MEMORANDUM

From:	Catherine Brimble Senior Landscape Officer		
Service	WBC Landscape and Trees	App No:	251984
Address:	Land south of Bridge Farm, Reading Road, Arborfield, Berkshire, RG2 9HT.		
Proposal:	Application for approval of Reserved Matters pursuant to Outline Planning Consent 223083 (as varied by 243190) for the erection of up to 11 no. commercial units to provide 6,986sqm GIA commercial / employment development predominantly within Class B8 and/or Class E (g) uses with supporting facilities within Class E uses comprising ancillary offices, trade counters and food/drink facilities with highway works and strategic landscaping. Details of appearance and landscaping to be considered.		
Type of Development:	Major Heavy industry/storage/warehouse		
Site Visit Made:	Yes/No

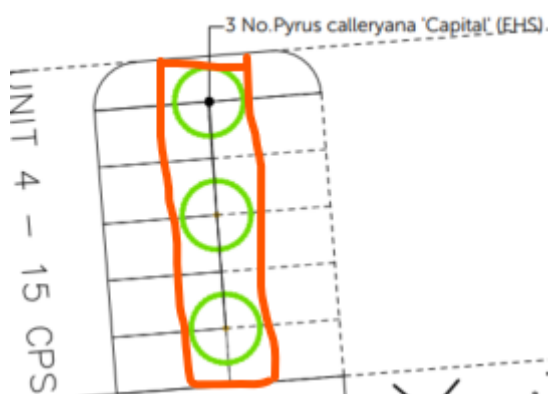
This RM application includes further details on material choice for the commercial units, and these are inherently different to the principles agreed through the Outline approval as it introduces lighter coloured timber type cladding and light grey roofing as indicated in the image below. This will make the units much more visible in the landscape and instead of visually receding, the lighter materials will visually stand out within landscape, which is not acceptable.

I also note the elevation drawings for the various units don't include any details for the lighter timber type cladding.

The materials will need to be revised in accordance with our expectations that were set out in the DAS approved under the outline application. These will need to consist of high-quality dark coloured materials.
